Technical Note

Project No: ITB16357
Project Title: Land South of A259, Angmering
Title: Additional Information – A/168/21
Ref: DS/ITB16357-008
Date: 11 October 2021

- 5.2.1 On that basis, the matters raised by WSCC in their response to planning application A/168/21 have been addressed, and a Stage 1 RSA will be undertaken upon resolution of the Departure from Standards applications.

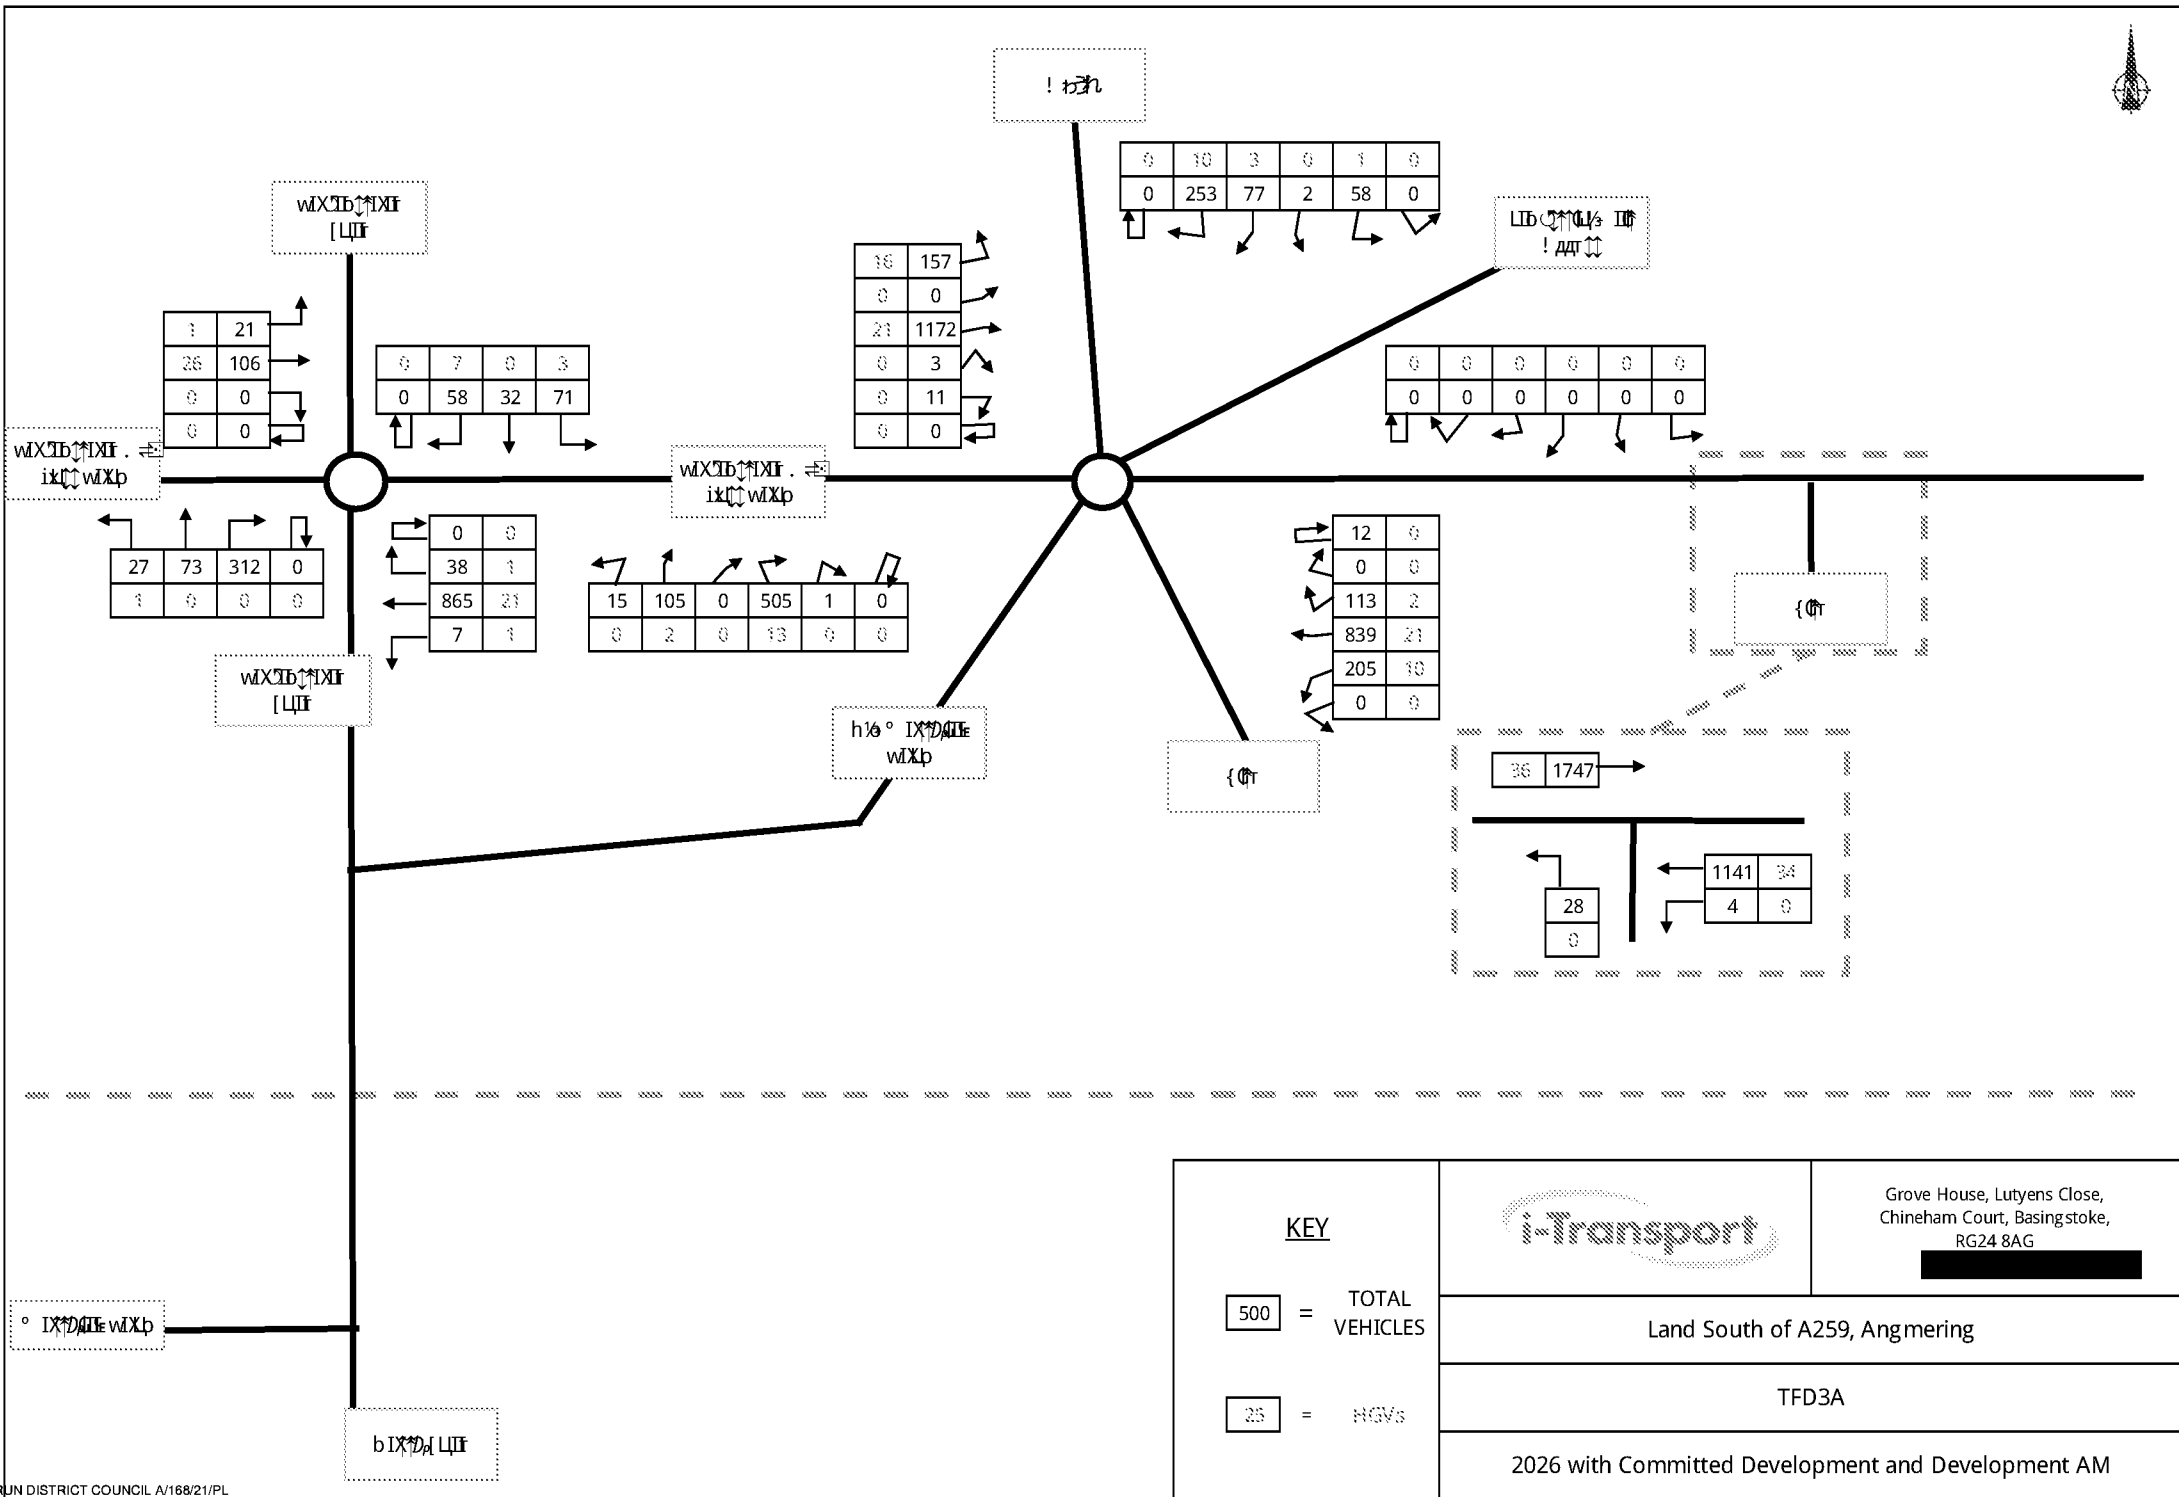
- 2.2 The design of the site access arrangement has been modified in order to remove the existing bus stop located on the live nearside lane of the A259 carriageway, as requested in the WSCC response. The amendment is shown in **Drawing ITB16357-GA-003 Rev E**.

- 3.1.9 Notwithstanding, the Applicant is willing to deliver some improvement of the cycle route that can be incorporated into, and constructed alongside, the site access works. A scheme of widening has been identified extending from the A259/A280/B2140 roundabout to the eastern boundary of the blue line plan. This includes the area in the vicinity of the TPO trees which will allow for hand dug construction techniques to be used, and the scope of the works in this area defined through the Section 278 Agreement. The works have been incorporated into **Drawing ITB16357-GA-003 Rev E**.
